C-400 90% Design Independent Technical Review Report and Implementation Plan

October 18, 2007

FINAL IMPLEMENTATION PLAN C-400 INTERIM REMEDIAL ACTION 90% DESIGN DOE-HQ INDEPENDENT TECHNICAL REVIEW RECOMMENDATIONS

Figure 2. TCE source material in the vicinity of Building C-400

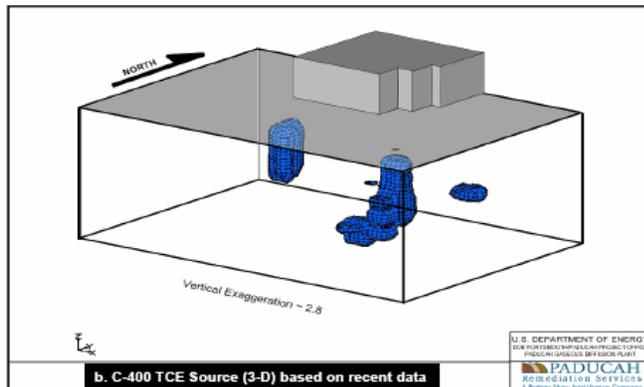
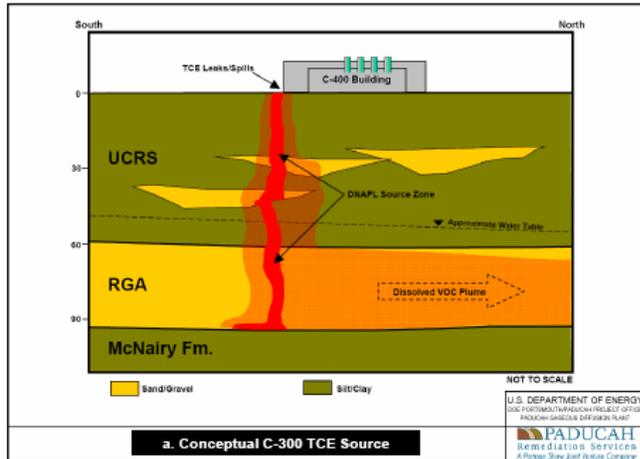
- Conceptual model shows released TCE migrating through soil (UCRS) down into aquifer (RGA).
- Area of higher concentration (DNAPL) delineated by use of “MIP” (Membrane Interface Probe).
- Report recommends:
 - Revisiting the data interpretation to ensure entire source area is treated.
 - collecting additional samples during installation of equipment to verify MIP results.
 - installing monitoring wells downgradient of treatment area as part of the action.

Figure 9. Idealized heating profile for a simple saturated system containing TCE DNAPL and water

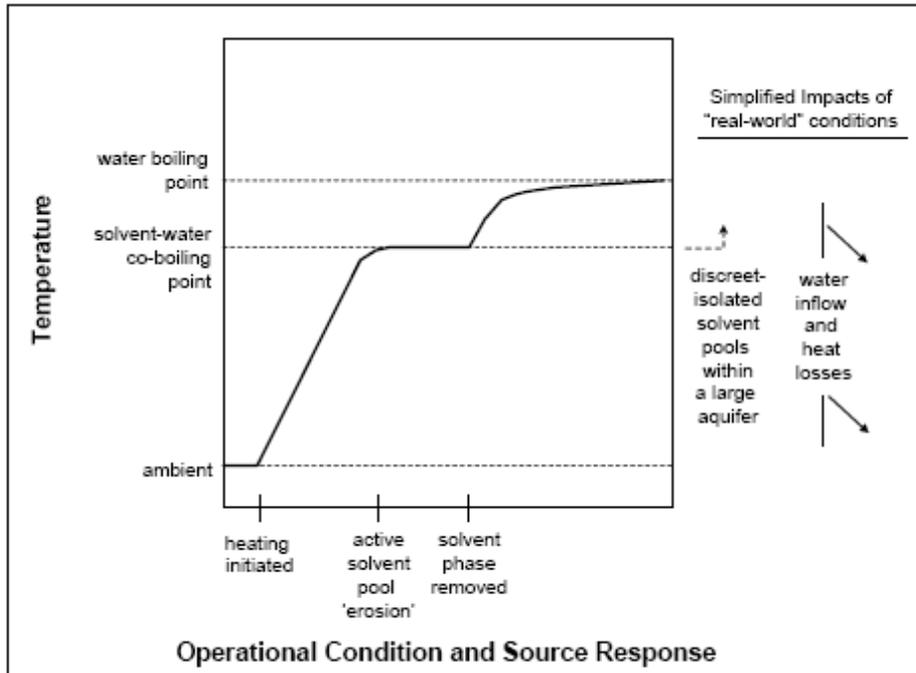
Primary recommendation is to work with regulators to define “asymptosis” in the final Design Report to ensure “asymptosis” is appropriately linked to:

- target temperature.
- removal of maximum amount of TCE mass.
- cost effectiveness of removal.

Figure 10. Simplified schematic of convection processes during ERH of the permeable portion of the treatment zone

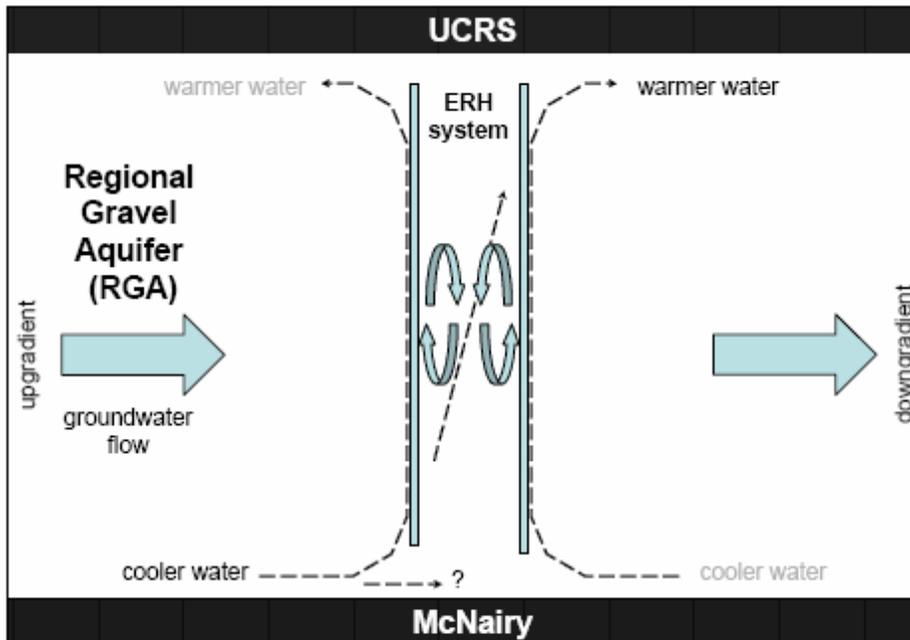
- Primary concern is uncertainty in the ability of ERH to heat effectively the TCE source area at the bottom of the RGA.
- Technology is complex. Use phased implementation to reduce uncertainties in electrode array design and improve chance of success.
